## SERVICE LETTER 112

### OPTIONAL HYDRAULIC POWER PACK TIMER RELAY INSTALLATION

<b>Aircraft Makes/Model(s):</b>	<b>Float Model(s):</b>	<b>Compliance:</b> Recommended	<b>By:</b> MAB
SA00637CH, SA00674CH, SA00713CH, SA0073CH, SA00804CH, SA00900CH, SA00910CH, SA001156CH, SA01185CH, SA01320CH, SA01272CH	2100, 2350, 3000, AND 3450 AMPHIBIAN FLOATS	<b>Part Number:</b> 1005052	<b>Approved:</b> SDW
		<b>Date:</b> 3/1/2022	<b>Revision:</b> F

**ELECTRICAL SCHEMATIC**  
**PUMP WIRING SCHEMATIC**  
 (RELAYS SHOWN IN RELAXED CONDITION)

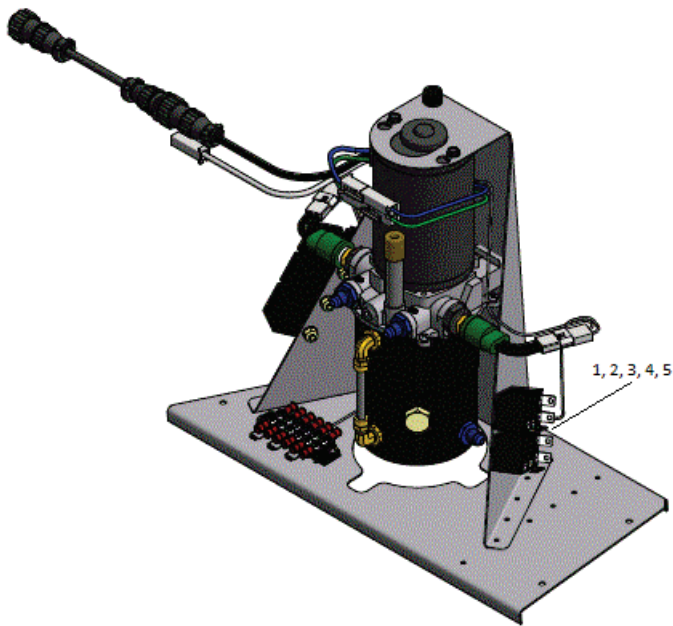
2. Remove backshell from three-wire round plug on pump side of connection.
  - a. Cut back heat shrink 1" from plug end.
  - b. Remove pin 1 from round connector.

- i. Cut off pin and strip insulation back on removed wire and one of the wires coming from terminals 1 and 4 from one of the timer delay relays. (It doesn't matter which relay.)

- ii. Using pin 66099-4 crimp both wires together in the pin and reinstall into pin 1 location in plug.
  - c. Remove pin 2 from round connector.
    - i. Cut off pin and strip insulation back on removed wire and the wire coming from terminals 1 and 4 from the other timer delay relay.

- ii. Using pin 66099-4 crimp both wires together in the pin and reinstall into pin 2 location in plug.
  - d. Reinstall backshell onto three-wire round plug

3. Disconnect two-wire molex plug on down pressure switch. (Down pressure switch is labeled "DN" in the pump casting at the hydraulic fittings.)
  - a. Remove pin 1 from molex housing. (Pin 1 is the pin in the pointed end of plug.)

- i. Cut off pin and strip insulation back on this wire and the wire coming from #3 terminals from the timer delay relay assembly.
    - ii. Using 02-09-1117 crimp both wires together in the pin and reinstall into molex housing pin 1.

- b. Reconnect down pressure switch
4. Connect the wire from #2 terminals from the timer delay relay assembly to ground using MS25036-102 terminal ring or equivalent.
